March 2021 BAR Decision

BAR 21-03-08

500 Court Square, TMP 530096000

Project: Replace four, apartment windows

1.1 WINDOWS

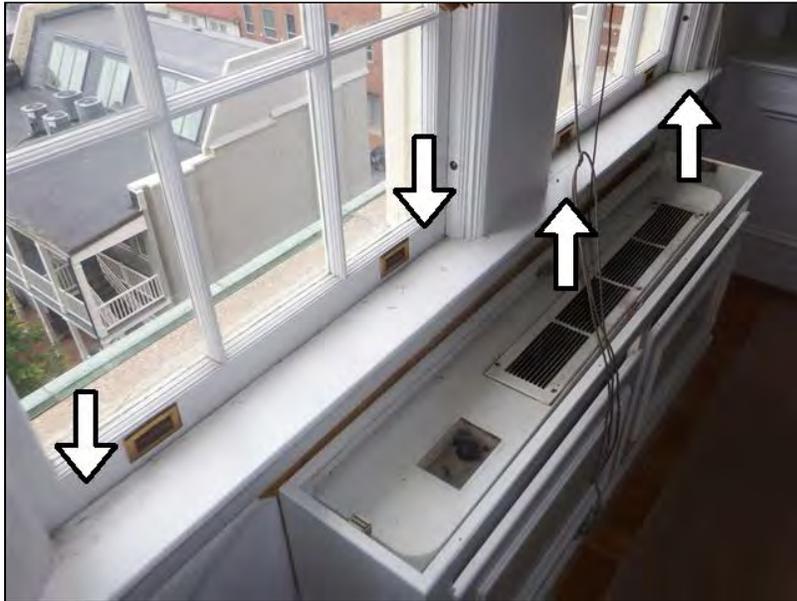
- D** (1) There was evidence of repeated water intrusion at the living room window sill, most notably at the left most jamb. The evidence extended down the wall and onto the floor. The area was checked with a moisture meter and found to be dry during the inspection.

D (2) Using reasonable force the two sashes where located in the pictures below could not be fully opened.

NOTE: The window treatment on the left window was deteriorated and not functioning properly as can be seen in the picture.
